SERVICE BULLETIN ASM-022

Product: Antenna Systems Monitor

Subject: Firmware 2.83 Release

Date: 14th September 2017

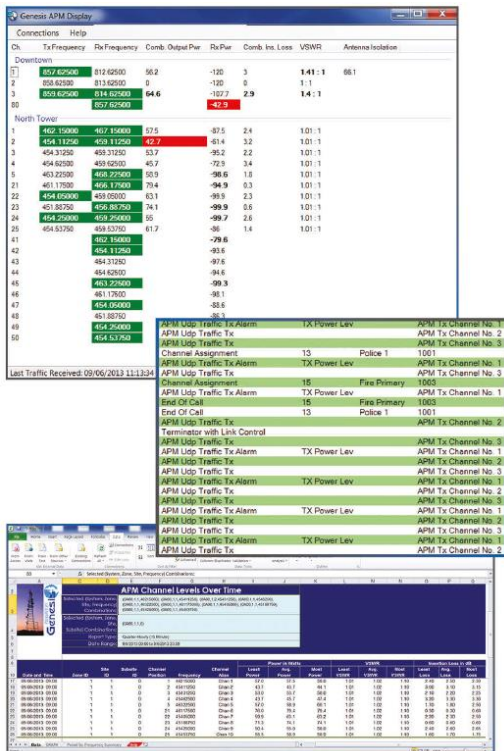
iii) Command Line Interface (CLI) Port enabling

To assist resiliency to Denial of Service (DoS) and port flooding attacks, the port used for Command Line Interface communications (port 23) can be now disabled if desired. Similar to SNMP port disabling, it is strongly recommended to only enable this port when the ASM is within a private network. The default configuration has this port disabled. This feature is also available in the *Configuration – Communications* screen.
